File No: CHE/17/00647/FUL  
Plot No: 2/60

#### ADDENDUM /UPDATE REPORT

#### PROPOSED VEHICLE SALES AND SERVICE CENTRES FOR THE SALE, SERVICE AND M.O.T OF MOTOR VEHICLES (REVISED DRAWING RECEIVED 14.05.2018) AT LAND OFF EASTSIDE PARK, EASTSIDE ROAD, CHESTERFIELD, S41 9BU FOR PENDRAGON PLC

- 'Plans and Elevations as proposed' drawing number 2878/23A
- 1.5 The revised drawings seek to increase the height of the vehicle sales building to incorporate a mezzanine 'first floor level' of the building creating approximately 80 sqm of additional floorspace.

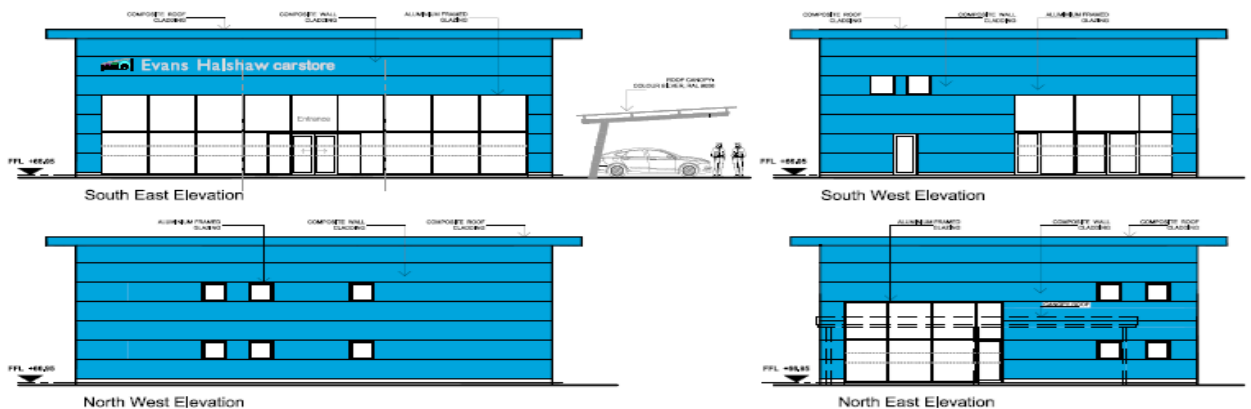
2.3.1 The main alteration to the scheme is the increase in height of the building by 2.5m, from 5.1m in height to 7.6m overall. Minor alterations are also proposed with respect to the fenestration arrangement within the north west, south west and north east elevations (see images above).

2.3.2 Overall it is considered that the design and appearance of the revised drawings are acceptable, having regard to the provisions of policies CS2 and CS18 of the Core Strategy in relation to design and amenity. Furthermore in respect of neighbouring amenity it is considered that the siting, scale and massing of the proposal is acceptable.

3.1 That the revisions to the scheme as detailed are accepted and the revisions should be incorporated into the decision issued subject to the satisfactory completion of the S106 agreement. Negotiations and the list of conditions as previously recommended (in Appendix A) shall be imposed with the exception of condition 2 which should be revised as follows:
